MARK	DATE	DESCRIPTIONS	BY	CH'D	CCO#
4	2/17/12	BIKEPATH PIPE SUPPORT	MM	BM	229
3	4/7/08	MECHANICAL MODIFICATIONS	VY	BM	31
2	1/18/08	MECHANICAL MODIFICATIONS	VY	BM	31
1	9/05/07	MECHANICAL MODIFICATIONS	BM	RM	31

CONTRACT CHANGE ORDER NO. _____
SHEET _____ OF _____

MECHANICAL PIPING SECTIONS & DETAILS NO.7

M-17

DETAIL 4 Alternate Pipe Support PS-6 ALT.

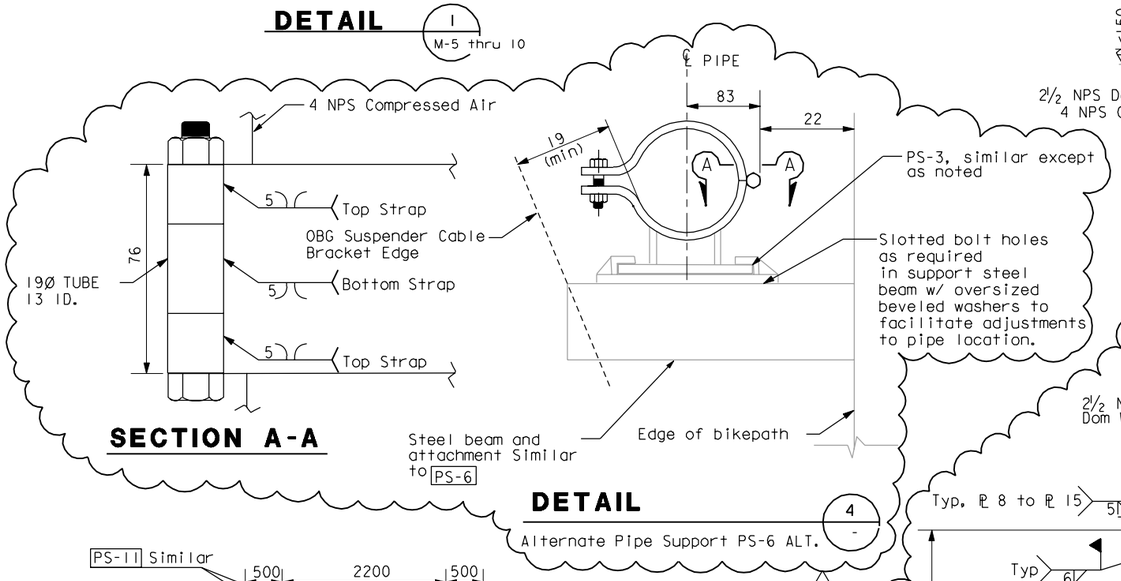
1. At locations where 4 NPS CA pipe installation per Detail PS-6 interferes with OBG suspender cable brackets, alternate pipe support, PS-6 ALT as shown in Detail 4 this drawing shall be used. Clearance between OBG suspender cable bracket and 4 NPS CA pipe shall be 19mm minimum at all locations.
2. Welds at the interface where 4" CA pipe is attached to plate 15 shall be ground smooth.
3. Paint finish shall be repaired per the procedure outlined in project special provisions.
